**AEGIS LIVING**  
RECOMMENDATION MEETING

25 JANUARY 2016  
DPD #3018400

ADDRESS: 8511 15TH AVE NE  
DPD PROJECT #: 3018400

5. SECURITY AND EXTERIOR LIGHTING

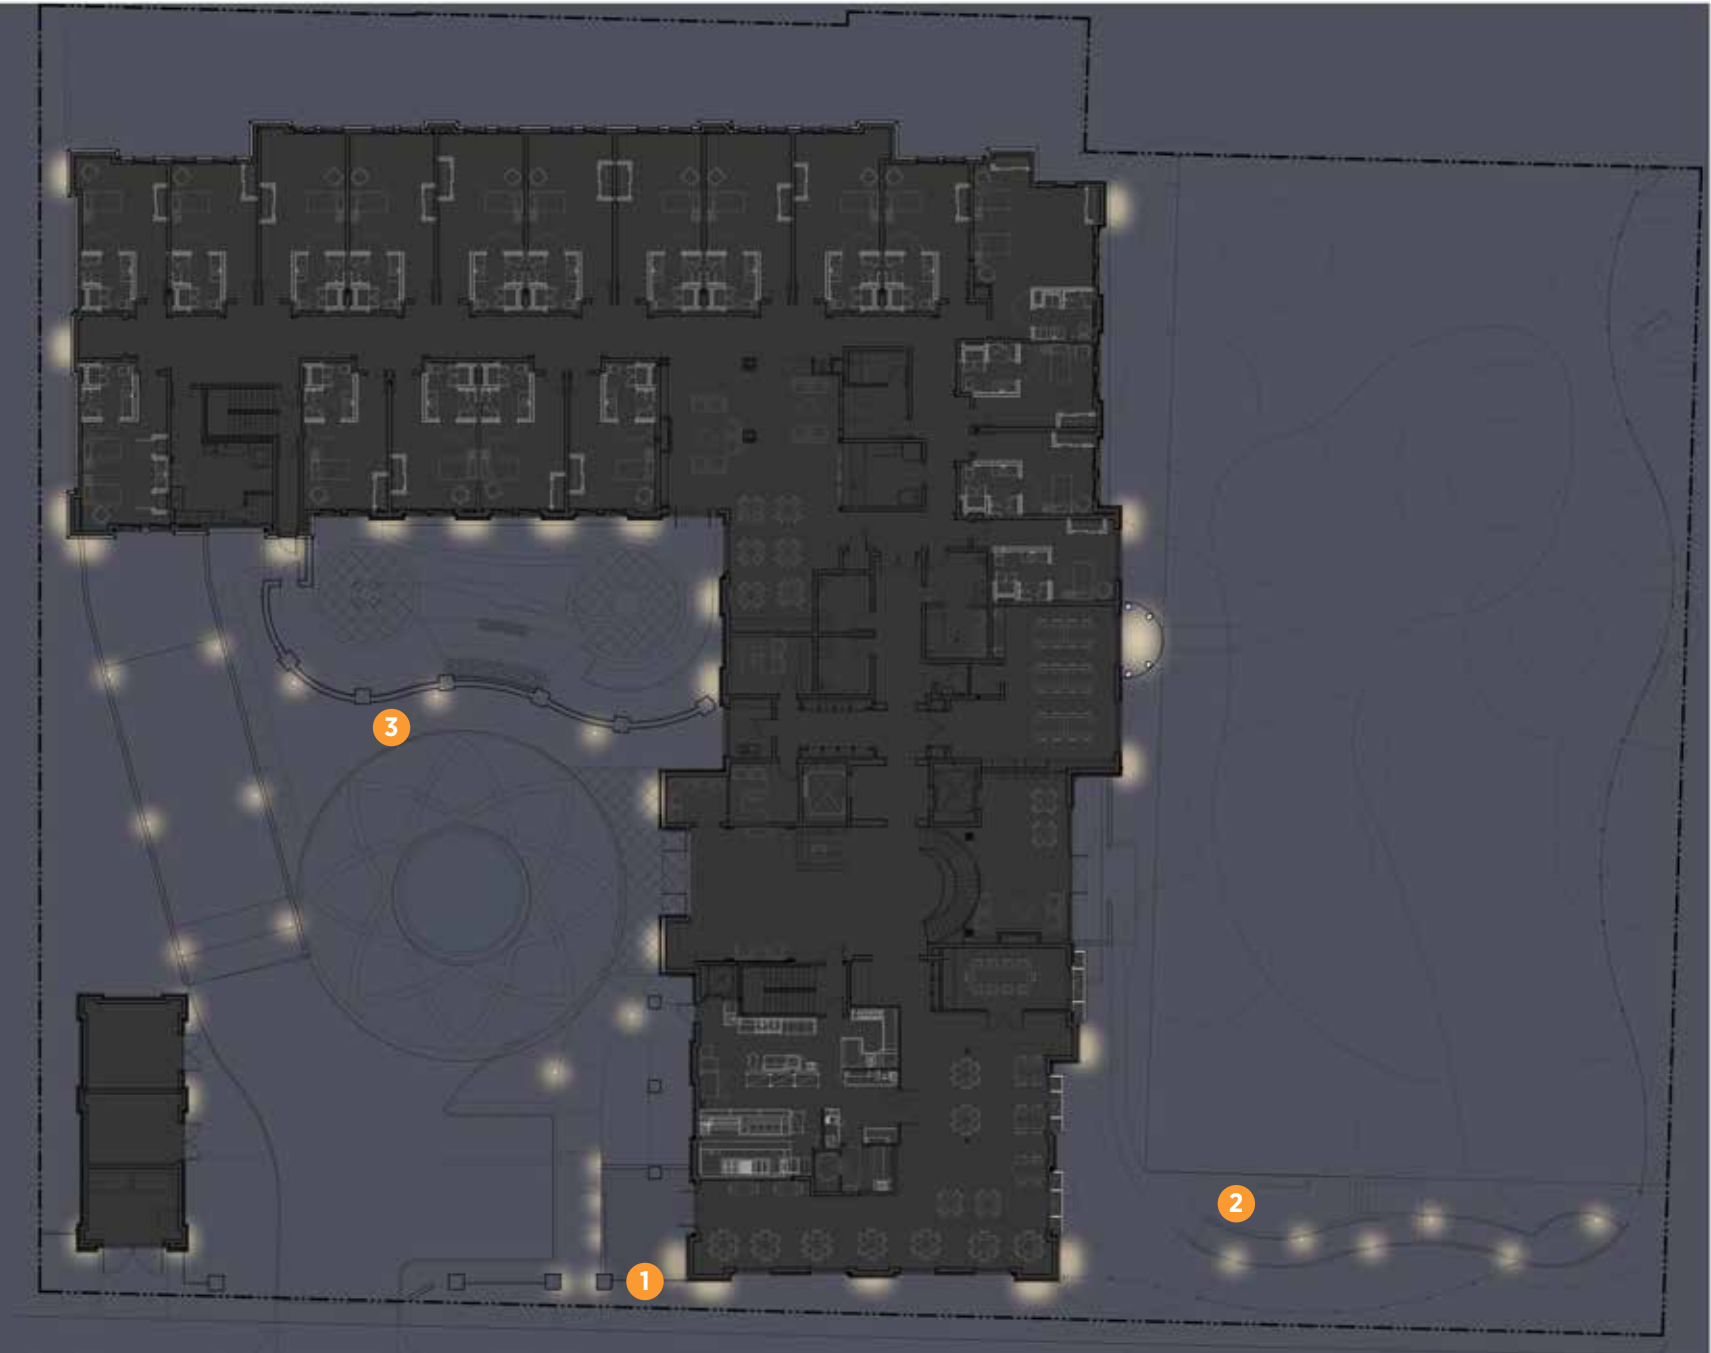
At the next meeting the applicant should address security and exterior lighting for the building.

The building uses lighting in three ways - exterior wall sconces, which accentuate the shape of the building, ground level step lighting, which assists pedestrians and vehicles in navigating the edges of paths and drives, and landscape uplighting, which adds depth to the landscaping design in the evening.

4. PEDESTRIAN/VEHICLE ACCESS AND SOLID WASTE COLLECTION

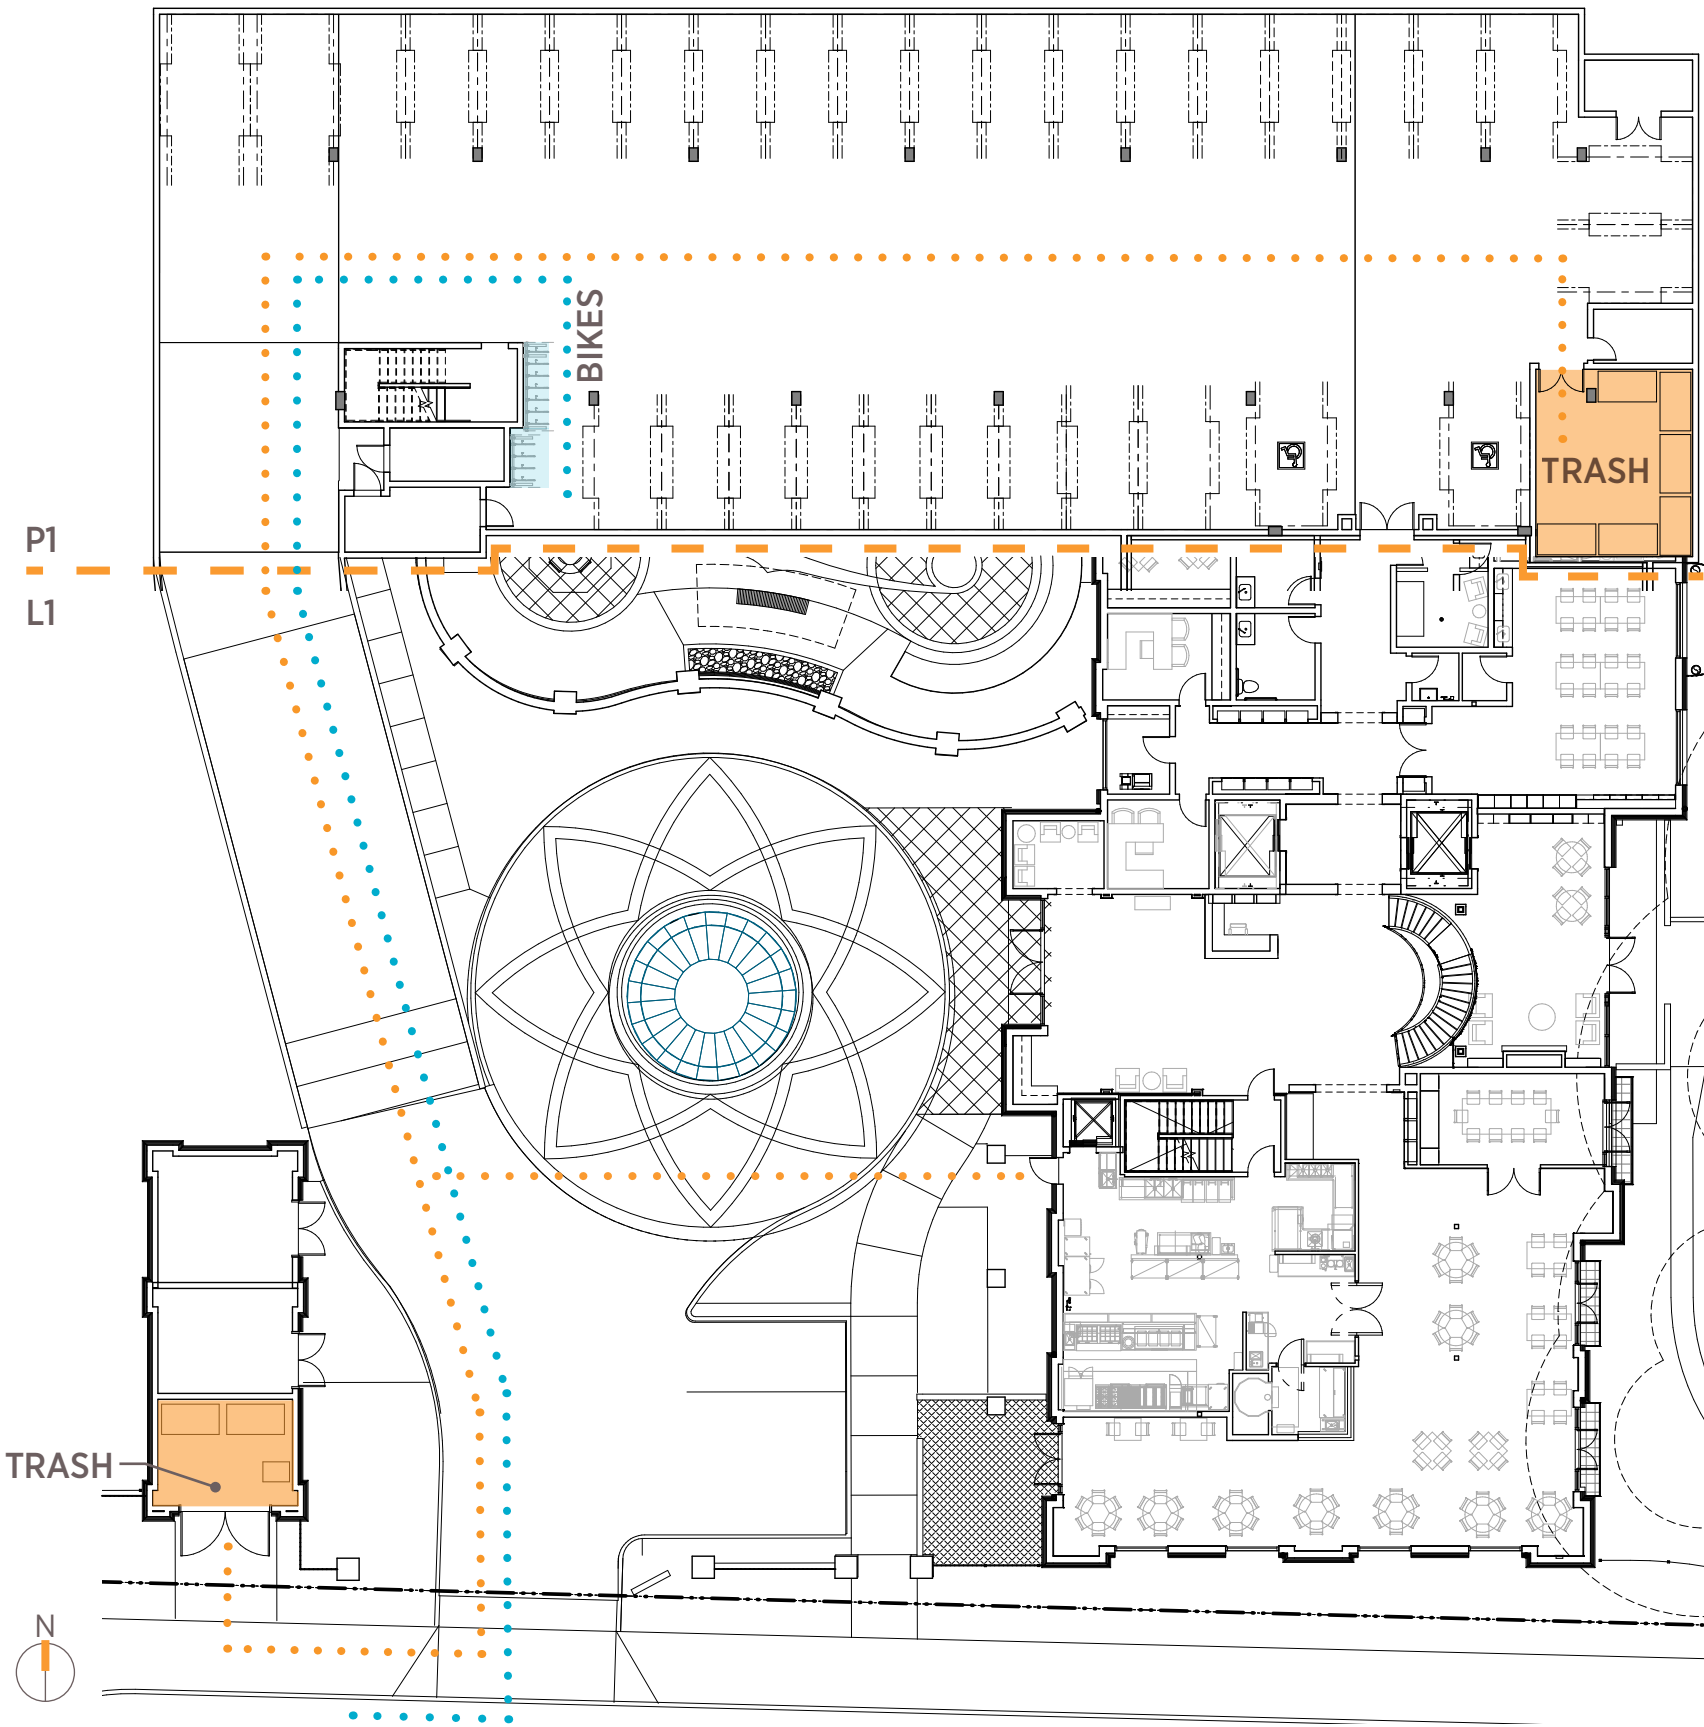
a. The Board would like to see more information on the solid waste storage location at the next design review meeting.

Trash is stored primarily in the basement of the building, and then placed in the accessory structure for trash pickup. The steel doors are detailed to create an attractive street face.

Bicycle parking is accessed by taking the parking ramp in to the garage, and bikes are secured near the entrance to the building in P1.

DEPARTURE 1

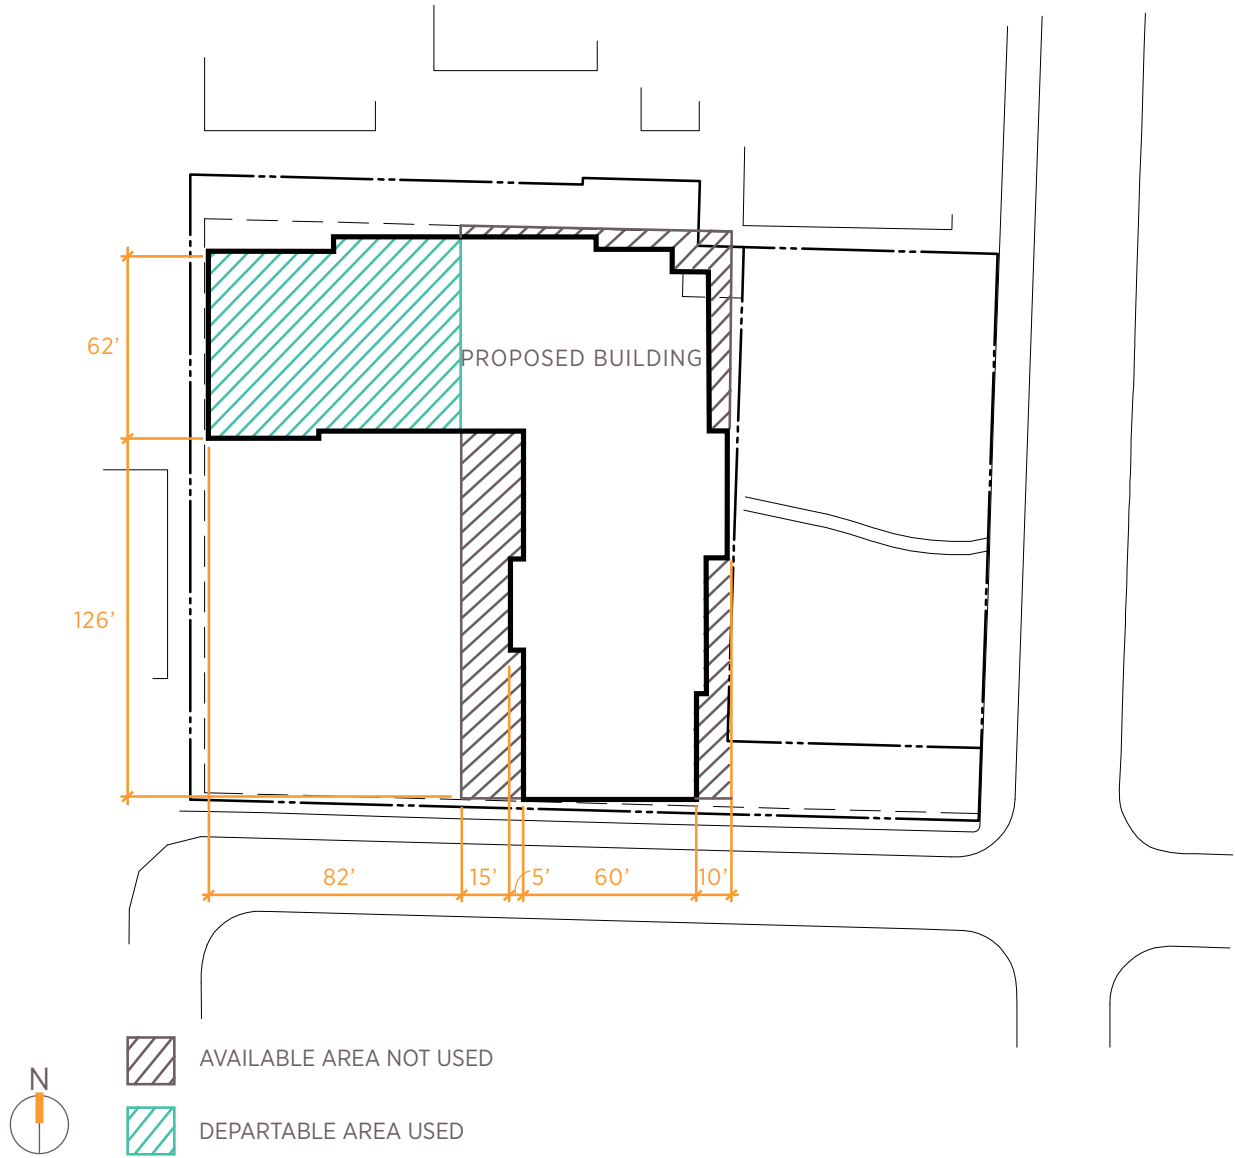
Requested Departure:  
• 172' structure width

The narrower street presence that the building has along NE 85th St allows for a stronger visual connection with the park as pedestrians walk along. The L-shape configuration pulls the main massing away from the street, minimizing the impact of the building size to the surrounding neighborhood and park views.

The narrow building massing along NE 85th St allows for equal entrances to the site for cars and pedestrians. Landscaping is blended from 85th, into the open court and smooths the transition from the site to the park.

The open court created with the L-shape building configuration opens the site to the public and lends to eyes on the street as well as the park.

**Setbacks**  
23.45.518

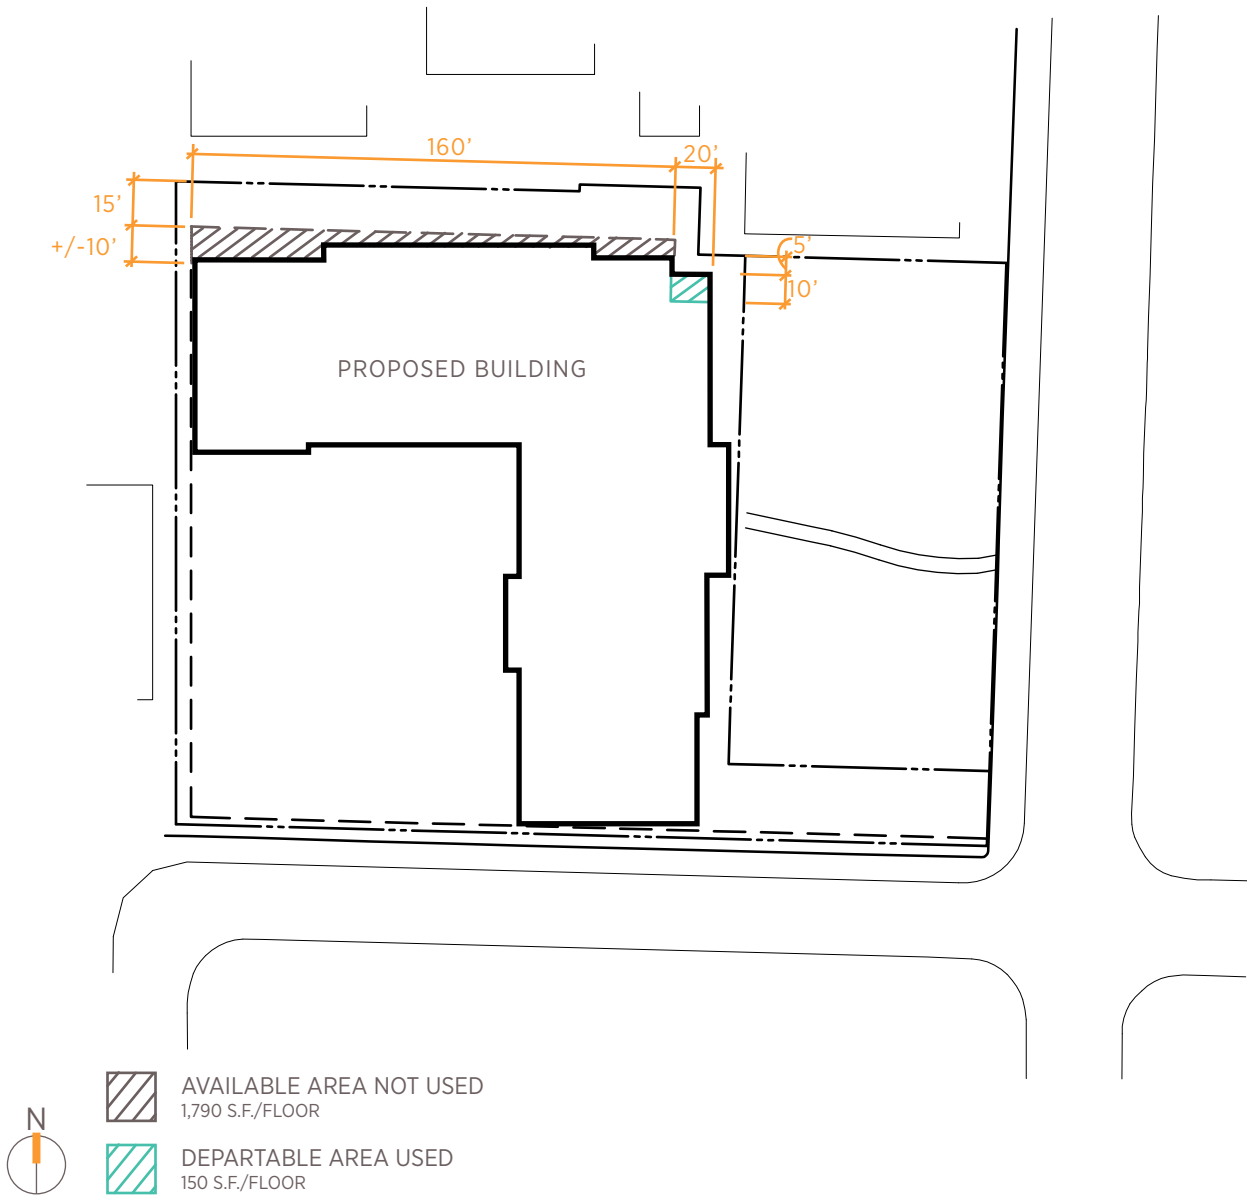
- A reduction from 15' setback to 5' setback along 20' of the North facade (rear setback.)

The proposed design exceeds the required setback distance for the majority of the length of the rear setback. The additional area needed at the Northeast corner of the site allows for a more significant portion of the massing along the North side of the site to be pulled back from the existing Townhouses.

The space between the existing townhouses and the North side of the building creates more space for landscaping and visual buffers between the two sets of residents.
